CHRISTUS POWELL ESTATES

APPLICATION NUMBER 16 DATE August 7, 2003
APPLICANT Christus Powell Estates
REQUEST Subdivision

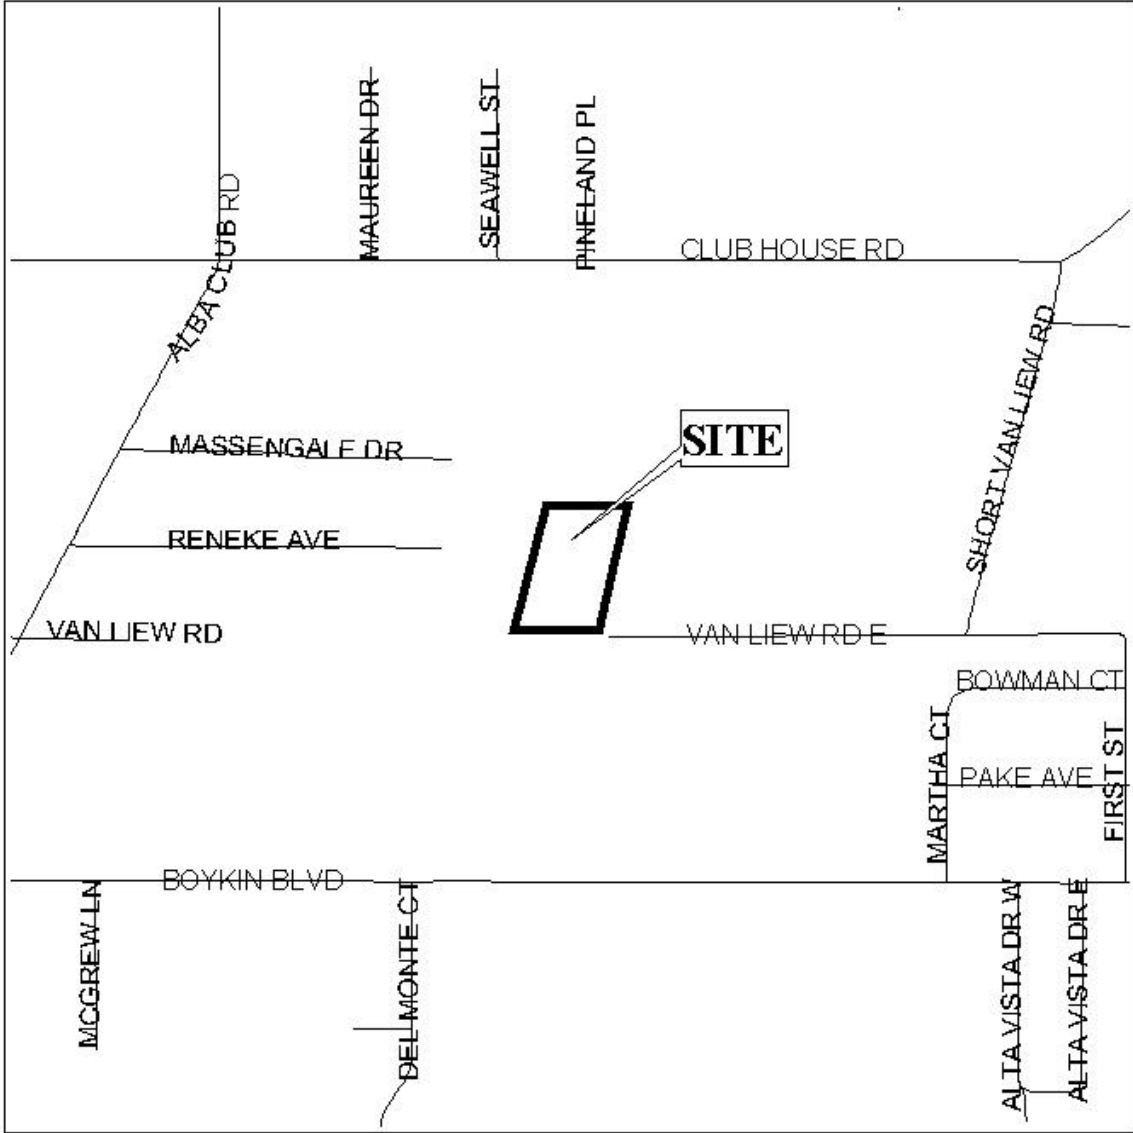
The plat illustrates the proposed 2 lot, 3.3± acre subdivision which is located on the North side of Van Liew Road at the West terminus of its improved right-of-way. The site is served by public water and sanitary sewer.

The purpose of the application is to subdivide the property into two lots. As illustrated on the Vicinity Map, the two proposed lots were actually part of a larger lot. However, the site is part of a court ordered subdivision and the overall boundaries of the proposed two lots correspond with the court order, thus the balance of the property should not be included on the final plat.

The site fronts the right-of-way for Van Liew Road; the plat submitted indicates the existing right-of-way is 19-feet wide and as such is extremely substandard. Additionally, Van Liew Road is a one-car-wide, gravel road from Short Van Liew Road (see Locator Map) to the Southeast corner of the site, a distance of approximately ¼ mile. The “road” ends at the corner of the site; it does not extend across the right-of-way frontage for the proposed subdivision.

Based upon the preceding, it is recommended that the application be denied for the following reason: 1) the site does not have direct access to a paved, standard-width, street.
